Process Sheet

Customer : CU-DAR001 Dart Helicopters Services	Drawing Name : HELI UTILITY BASKET LH/RH 350/355
Job Number : 43941	
Estimate Number : 10208	
P.O. Number :	Part Number : D350607043
This Issue : 08/12/2008 S.O. No. :	Drawing Number : D350-607 REV F P7-9
Prsht Rev. : NC	Project Number : N/A
First Issue : / / Type : LARGE FAB ASSY	Drawing Revision : F
Previous Run : 43819	Material :
Written By :	Due Date : 22/12/2008 Qty: 1 Um: Each
Checked & Approved By : <u>JUD 08.12.08</u>	
Comment : Est Rev:E as Per DSI9318 06-01-24 JLM Est Rev:F ECN1068 07-12-21 DD verified by:

DART SERVICE INSTRUCTION

TO AMEND INSTALLATION INSTRUCTIONS D350-607 REV. F

DESIGN <i>CP</i>	DRAWN BY <i>CP</i>	DART AEROSPACE LTD HAWKESBURY, ONTARIO, CANADA	
CHECKED <i>[Signature]</i>	APPROVED <i>[Signature]</i>	DRAWING NO. DSI 9318	REV. A SHEET 1 OF 1
DATE 06.01.06		TITLE WASHER ADDITION	SCALE NTS
A	06.01.06	NEW ISSUE

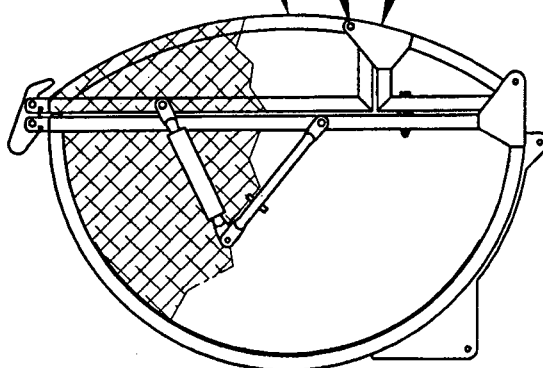
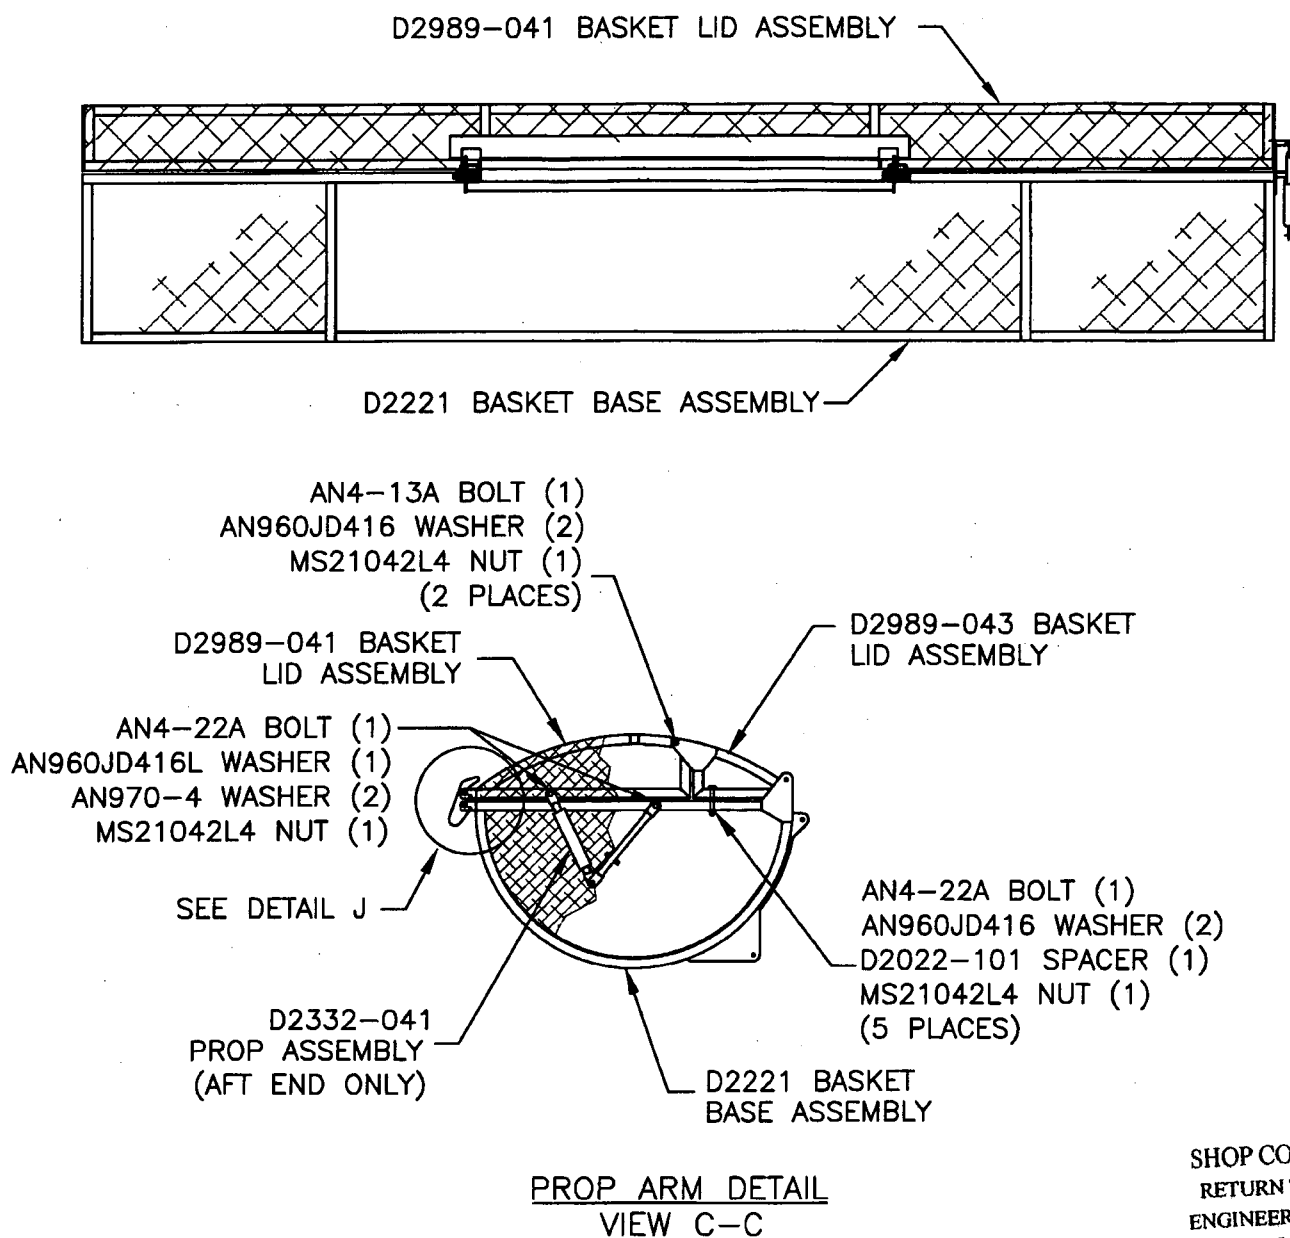
To reduce the possibility of damaging the finish, a **NAS1515H4** washer (2 places) has been added between the hinge plate and basket frame on the **D350-607-043/-047 Heli-Utility-Basket**.

The corrected bolt stackup from Figure 5 of installation instructions D350-607 Rev. F is given below:

AN4-13A BOLT (1)
AN960JD416 WASHER (1)
HINGE PLATE (REF)
NAS1515H4 WASHER (1)
BASKET FRAME (REF)
AN960JD416 WASHER (1)
MS21042L4 NUT (1)
(2 PLACES)
